Sent: 5/11/2019 4:43:42 PM
Subject: Attn:Catriona Shirley - Submission for DA2019/1069 205 Riverview Rd
Attachments: Comments on DA2019-205 Riverview.docx;

Comments on DA2019/1069 205 Riverview Rd Avalon Beach

205 RIVERVIEW ROAD AVALON BEACH

SHADOW ELEVATIONS - 203 RIVERVIEW ROAD

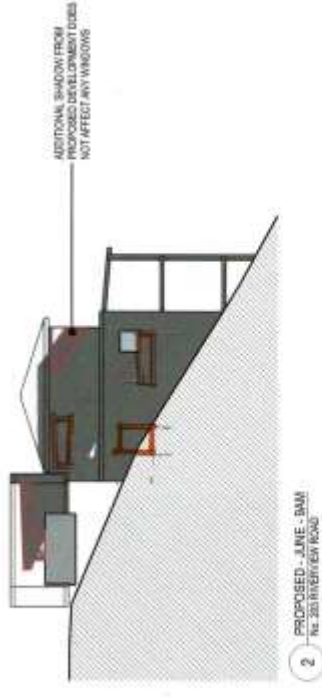
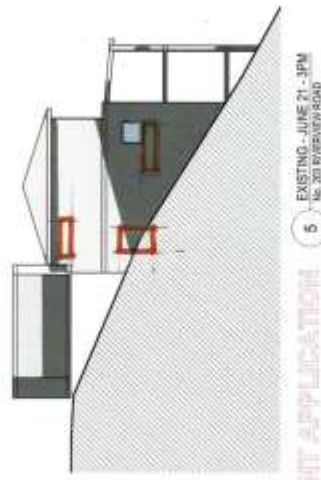
We note that the shadow diagrams submitted in the DA have not included affected windows on the northern side of the 203 house, hence we have estimated their positioning and amended these drawings to include the windows that are being impacted by overshadowing - see the attached diagrams.

2. **Overshadowing** - The increased bulk will increase the overshadowing (see attached shadow diagrams with all windows included) therefore does not meet the objectives to allow an increase in height over 8.5m

- a. Existing windows on the northern side of 203 Riverview road have not been shown on submitted shadow diagrams, in particular a living room window on the top level, and kitchen and bedroom windows on the second level.

- b. From our workings sunlight at mid-day to both the living room window on the top level and the bedroom window will be lost due to the proposed development, with the bedroom window being fully overshadowed in mid winter from mid day til later in the afternoon (see the attached shadow diagrams amended to allow for the windows that have been omitted).

- c. We estimate that the overshadowing is primarily due to the connection of the carport to the house and increase in overall height. The existing separation between the house and carport allowed for sunlight from around 10am until afternoon (a setback from the boundary to allow for sunlight was a requirement asked for by 203 Riverview in the DA process for the carport). Reducing the high point on the carport roof and retaining a roof size that is similar to the current carport roof (ie no further increase in the size of the carport roof), and setting the new top floor at least *another* 2 metres from the boundary may reduce this impact.

- d. The drying courtyard on north side of 203 will be completely overshadowed during midwinter
